Access Compliance Report Public Rights-of-Way (Curb Ramps)

Main Street: KATELLA_AVE Cross Street: GILBERT_ST Location: NW

ADA ID: RPAT210916101520 Ramp Type: Type 1 - Perpendicular Diagonal Initial Pass/Fail: Pass Overall Compliance: No Severity Score: 5

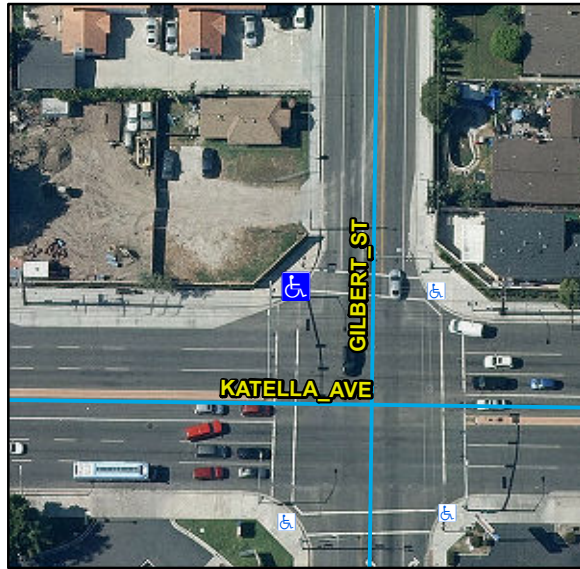
R304.2.2, R304.2.1, R304.5.4, STD 1115

Remove & Replace Curb Ramp With Two New Directional Ramps or Equivalent. Remove & Replace Gutter.
